Re: **Garcia Volkswagen, 8201 Lomas Blvd NE**  
**Permanent Certificate of Occupancy - Transportation Development**  
**Architect's Stamp dated 07-05-12 (J19-D003)**  
**Certification dated 01-08-13**

**Re: GARCIA VOLKSWAGEN  
Grading and Drainage Plan  
Engineer's Stamp Date 6/26/2012 (J19/D003)**

**RE: GARCIA VOLKSWAGEN (J19/D003)**

**Re: GARCIA VOLKSWAGEN  
Grading and Drainage Plan  
Engineer's Stamp Date 6/13/2012 (J19/D003)**

# EXHIBIT A

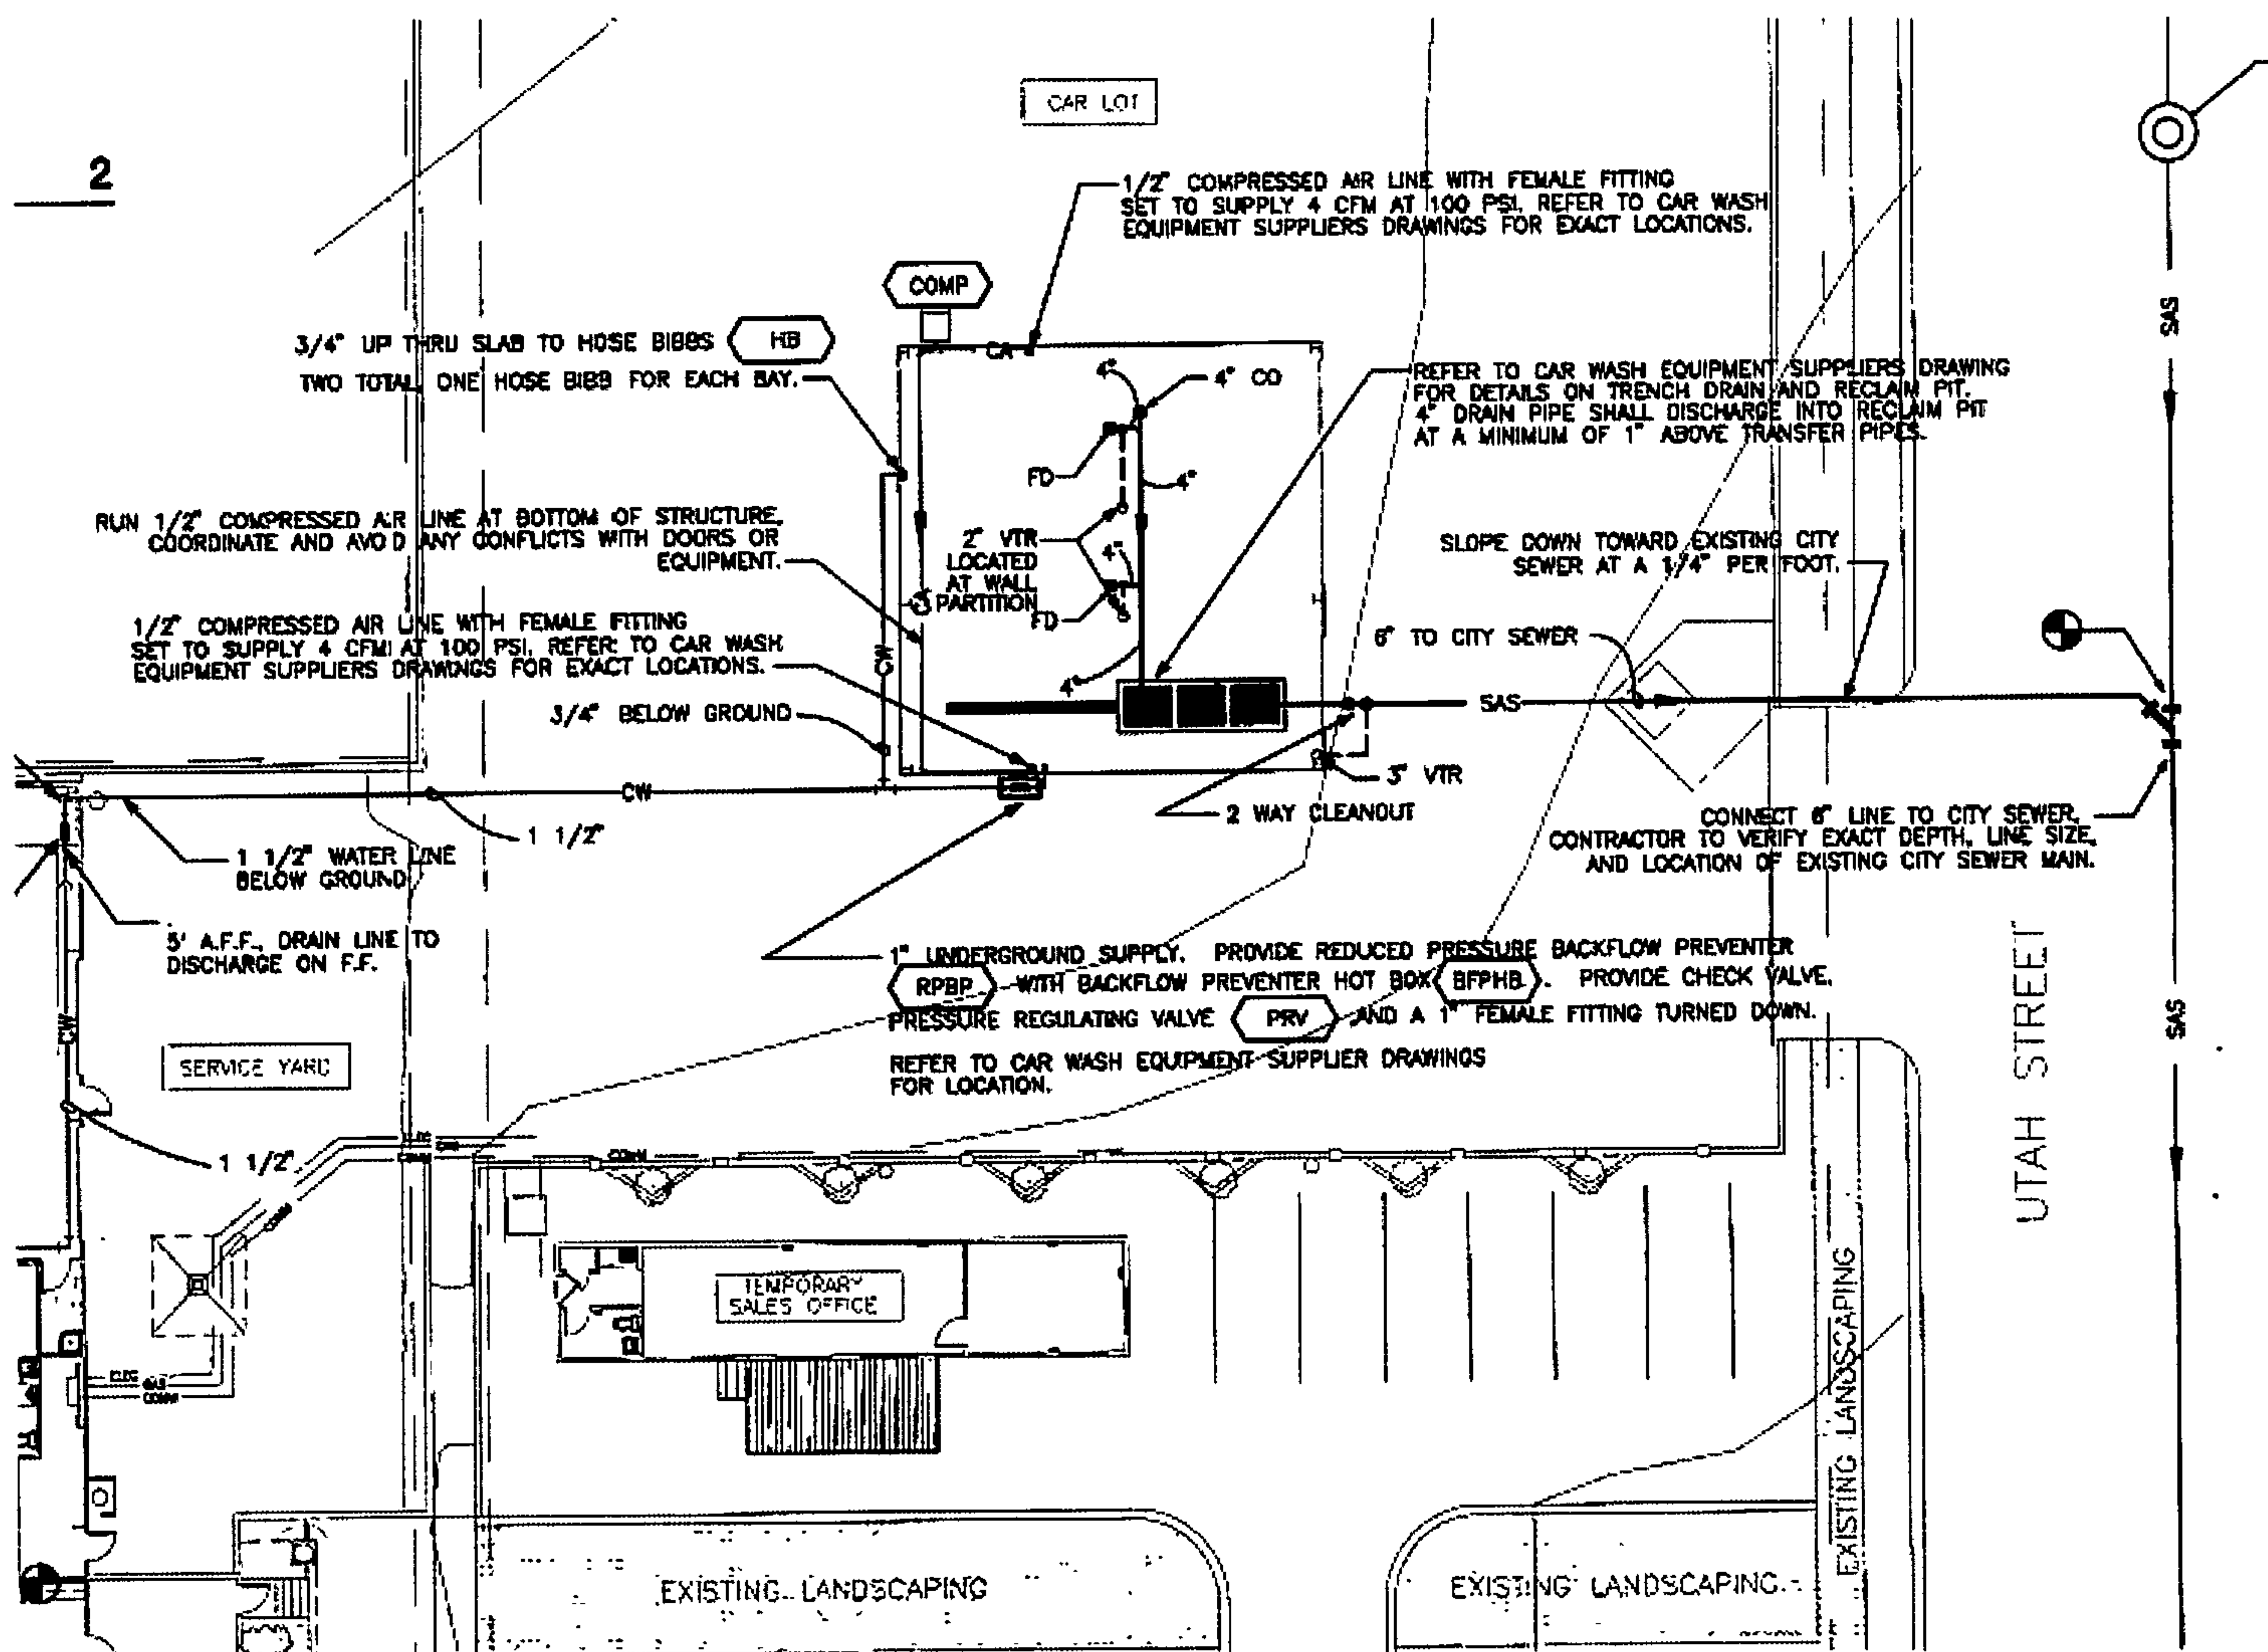
- The runoff from the existing Car Wash should drain to the sanitary sewer system. Please coordinate this connection with ABCWUA.
- Other runoff should be diverted away from the Car Wash and into the storm drain system.

1. Based on the construction documents for the existing car wash, the car wash area drains to the sanitary sewer system. See attached Exhibit A for the SAS design from the original plan set.
